Gerry Duggan's: Submission to MetroLink Railway Works Application

ABP- 314724-22

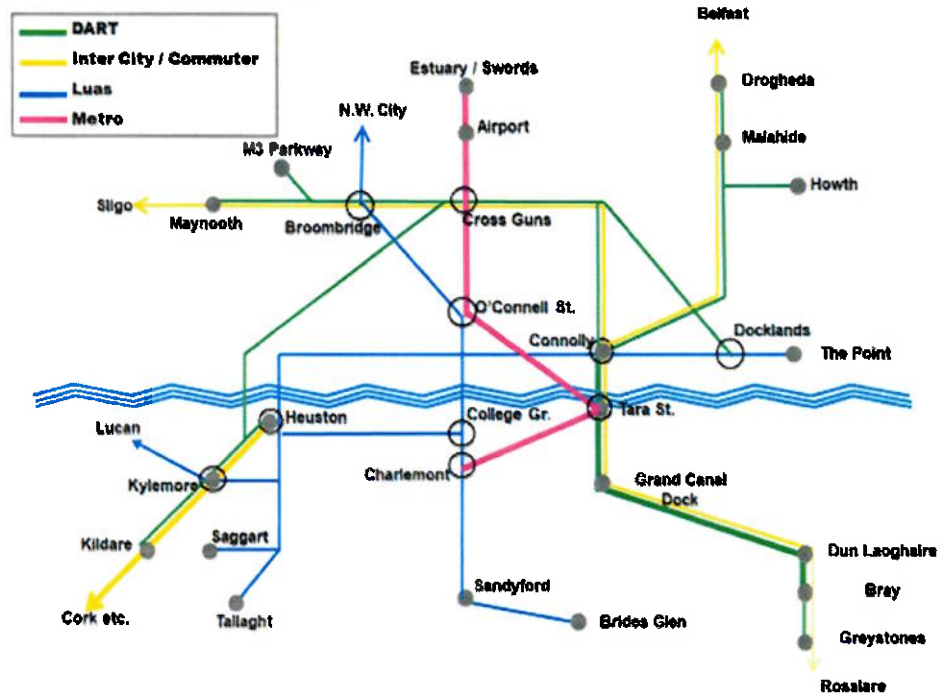
The present MetroLink proposal does not meet this test but it would if, instead of being routed to Charlamont, via Tara St. it was instead routed from O'Connell St. to St. Stephen's Green West and Cathal Bruagh Barracks.

This would facilitate its extension to the South West Quadrant of the city at a future date and for its further integration with the heavy rail network, when the Dart Interconnector is completed. The resulting fully integrated rail network is contrasted with the NTA proposal in the following page.

This solution would eliminate the problems at Tara St. Trinity College's East Campus and Charlamont and would make maximum use of the design work done on Metro North, thus shortening delivery.
